SECTION 3 CLARIFICATIONS AND REVISIONS

3.1 DRAFT EIR NO. 331

3.2 MOUNTAIN PARK SPECIFIC PLAN

Revised Exhibit 3-8

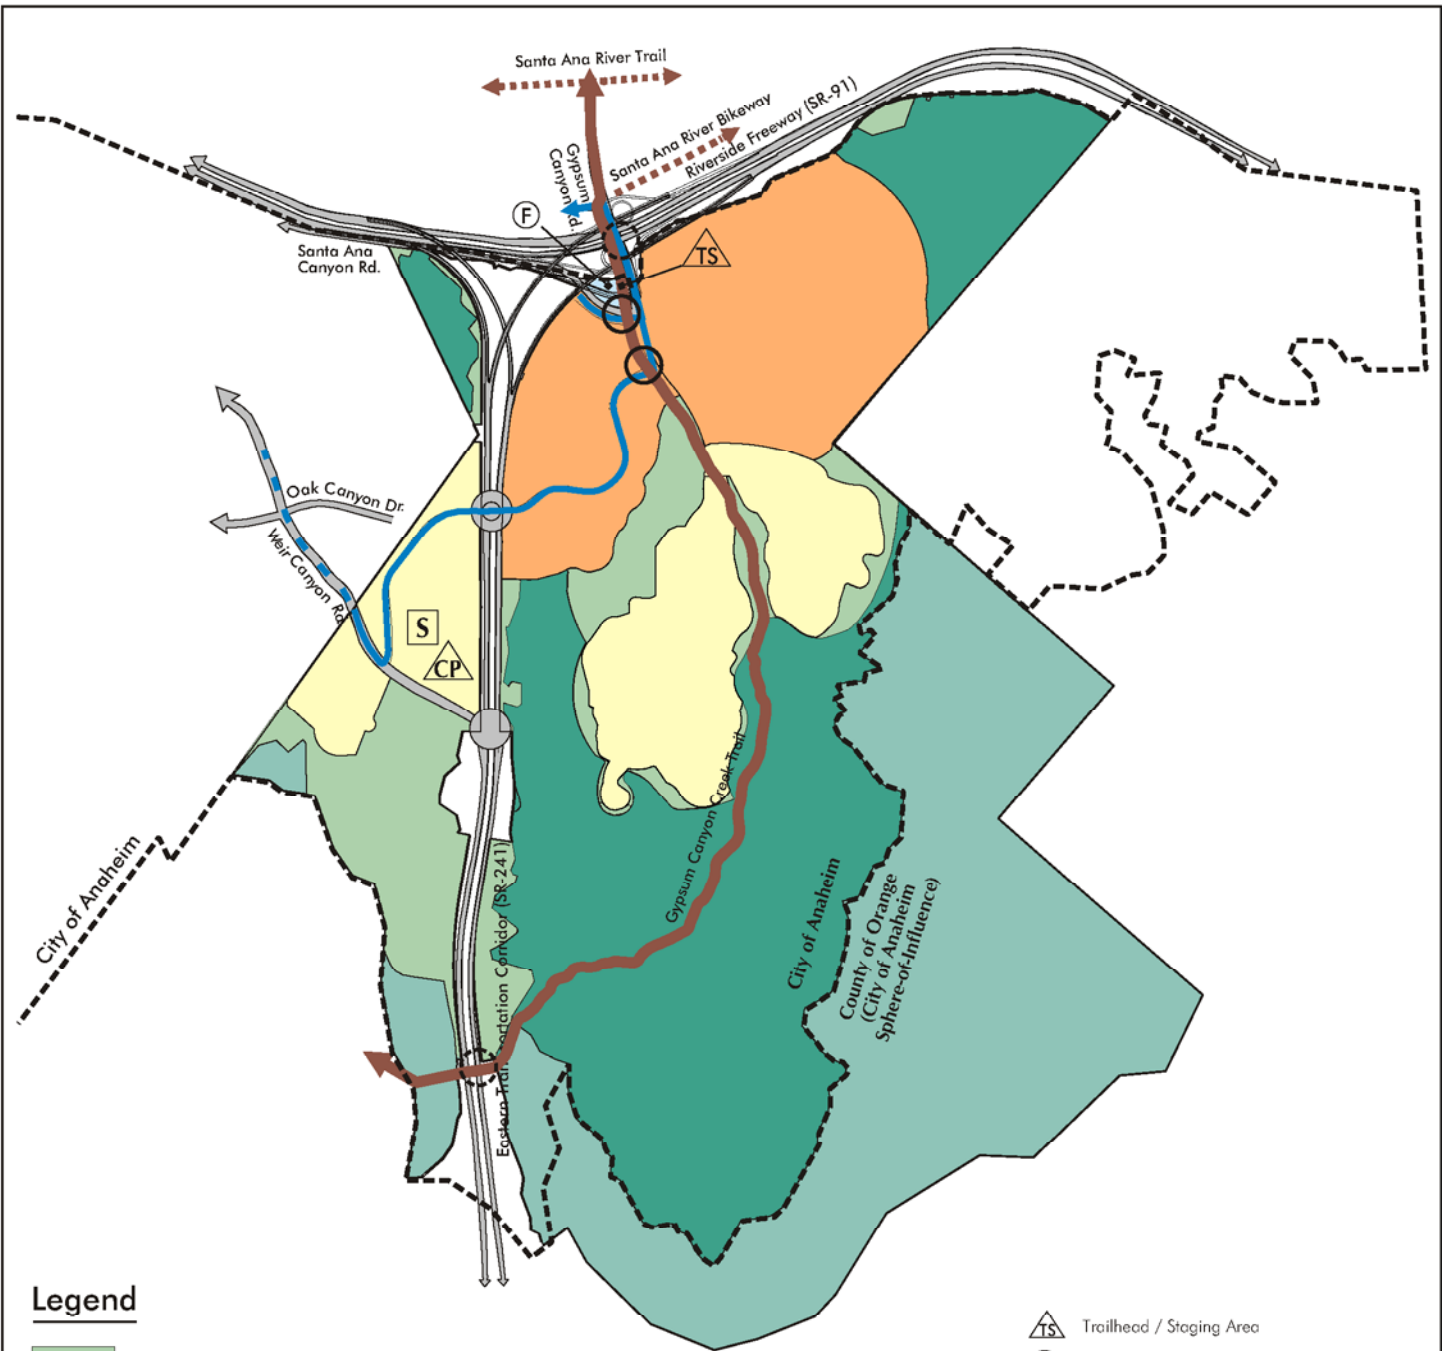
2. Exhibit 3-8 is hereby revised to change “Featherly Regional Park Trail” to “Santa Ana River Bikeway” and is provided at the end of this section.

Revised Exhibit 5

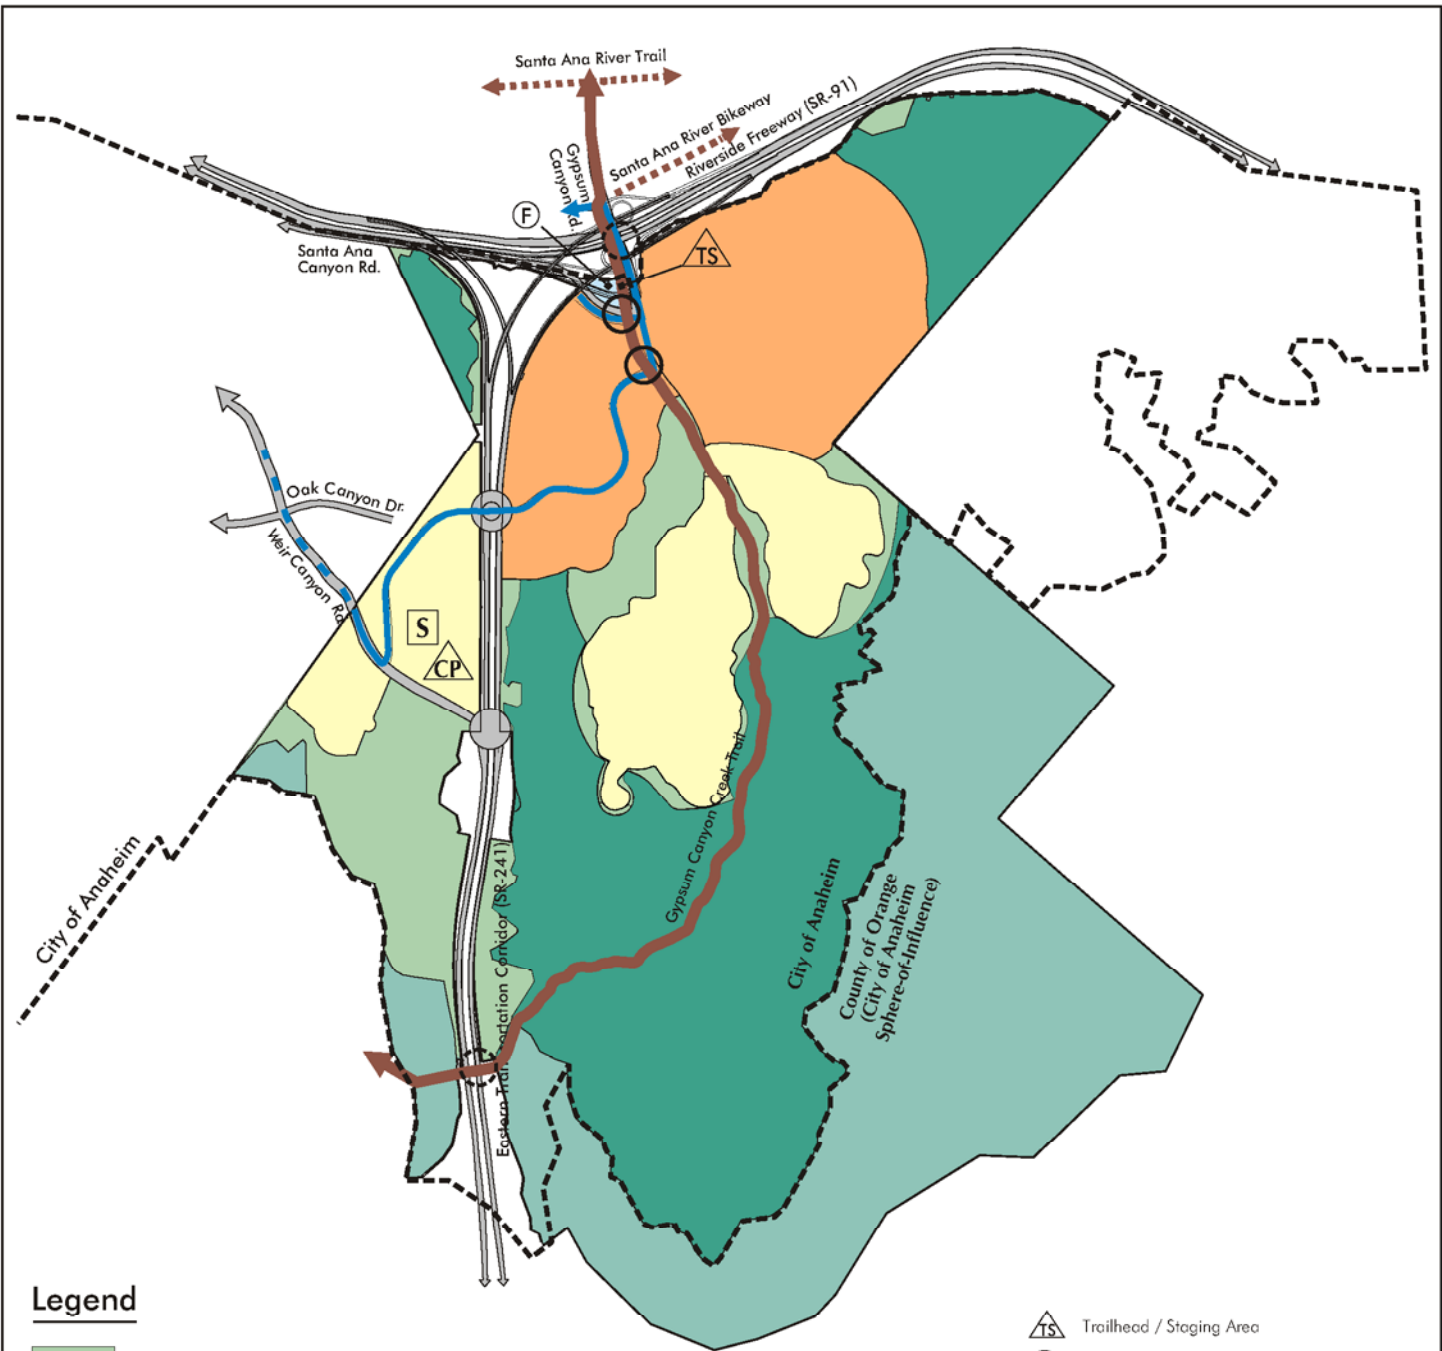
1. Exhibit 5 is hereby revised to change “Featherly Regional Park Trail” to “Santa Ana River Bikeway” and is provided at the end of this section.
